KBN Engineering & Applied Sciences, Inc.

April 4, 1990

Re: Technical Comments to the Draft BACT Determination
Prepared by FDER on the Hardee Power Station

TECHNICAL COMMENTS TO THE DRAFT BACT DETERMINATION
PREPARED BY FDER ON THE
HARDEE POWER STATION

Figure 1 FLUE GAS EQUILIBRIUM COMPOSITIONS - GAS NO. 2

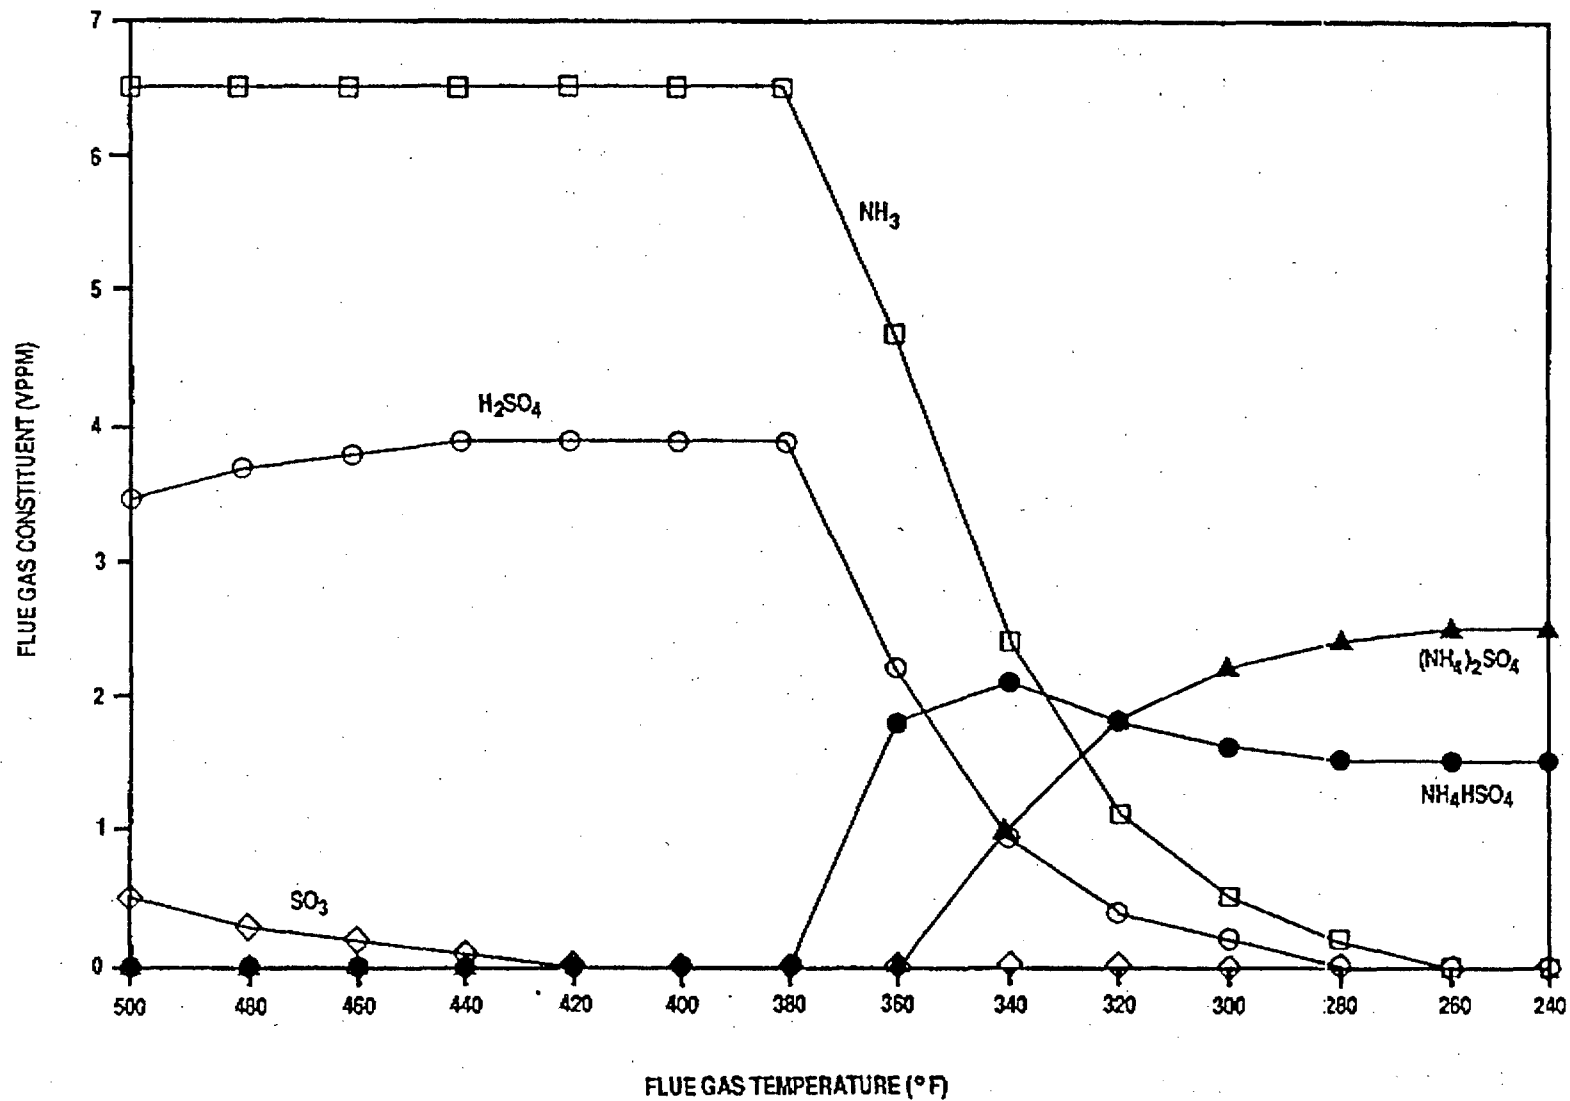
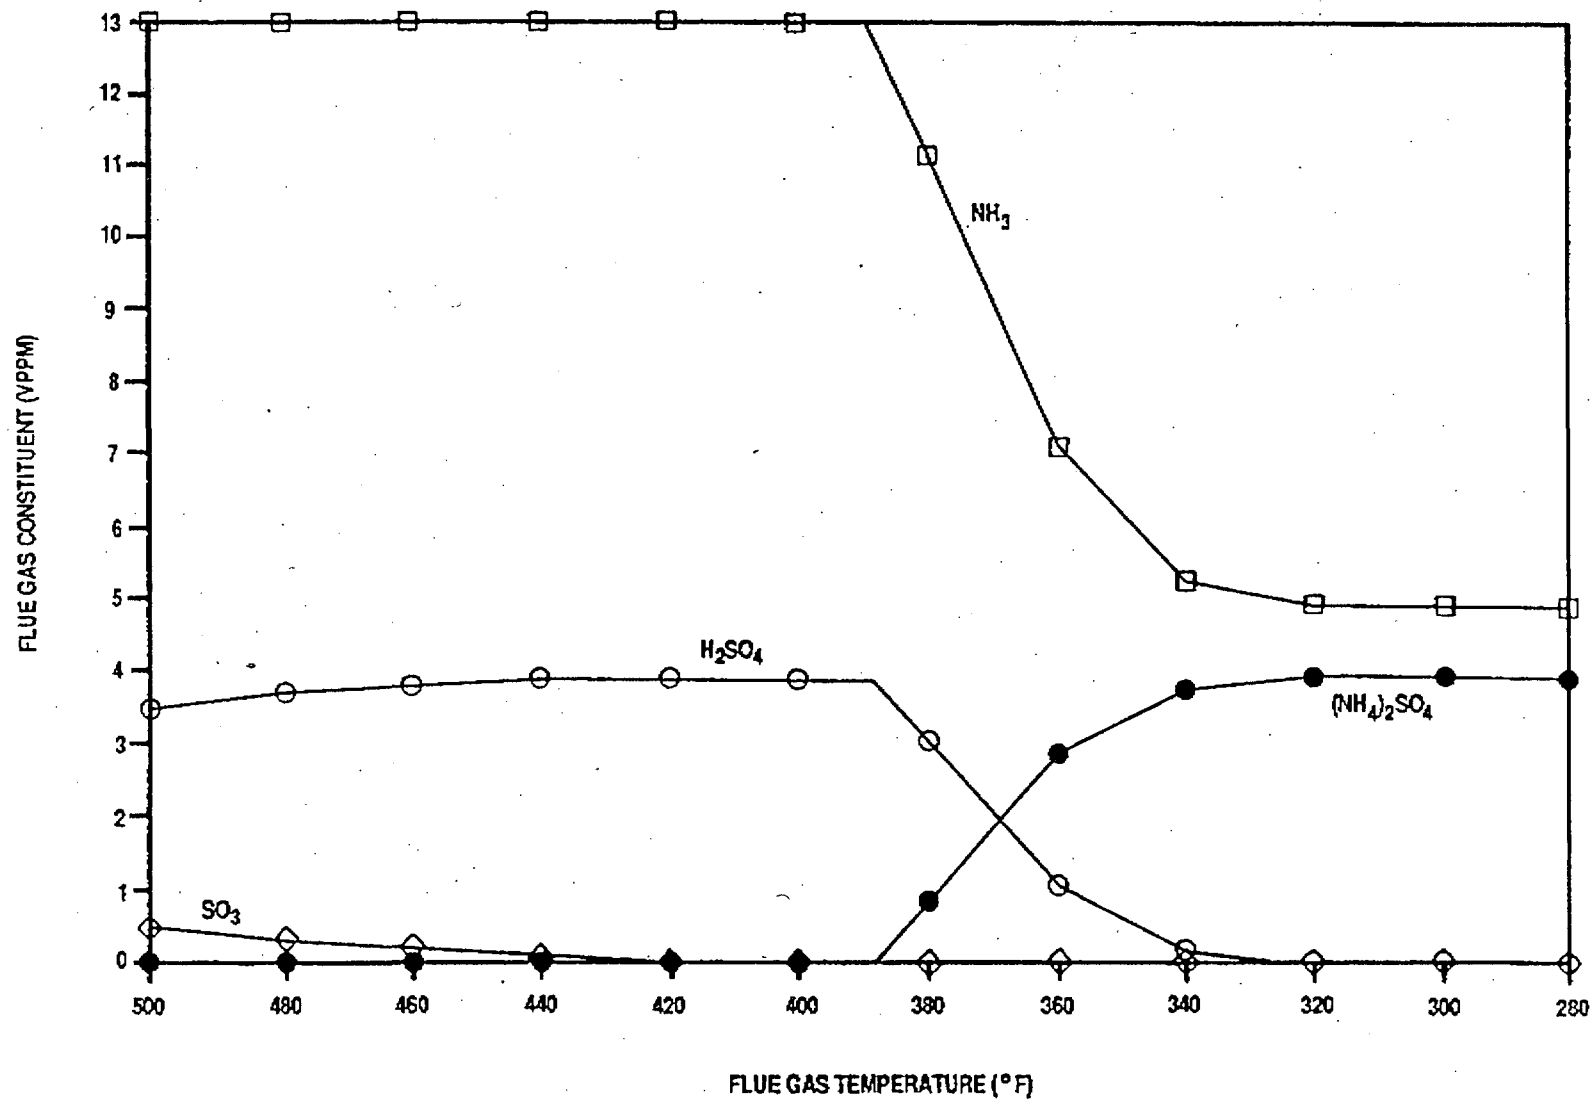
The formation of ammonium bisulfate and sulfate downstream of the SCR reactor is a complex function of gas composition and temperature. This problem was evaluated in a study recently conducted by Exxon for General Electric Company. The results of Exxon's calculations are shown in Figures 1 and 2. Both calculations used an exhaust gas composition based on firing 0.2 percent sulfur distillate oil. In Figure 1, the unreacted ammonia leaving the SCR was assumed to be 6.5 ppm, and in Figure 2 it was 13 ppm. In Figure 1, ammonium bisulfate begins to form at temperatures below 380° , and below 360° , ammonium sulfate forms as well. By the time the gas reaches 260° , all of the sulfur present as either SO_2 or as H_2SO_4 has reacted, consuming all of the excess ammonia as well. Figure 2 shows

A further problem for SCR operation associated with firing sulfur-bearing fuels is the formation of particulate matter in the SCR. For the example shown in Figures 1 and 2, the sulfate particulates would increase the PM10 emissions by 49 and 55 lb/hr for each gas turbine, respectively.
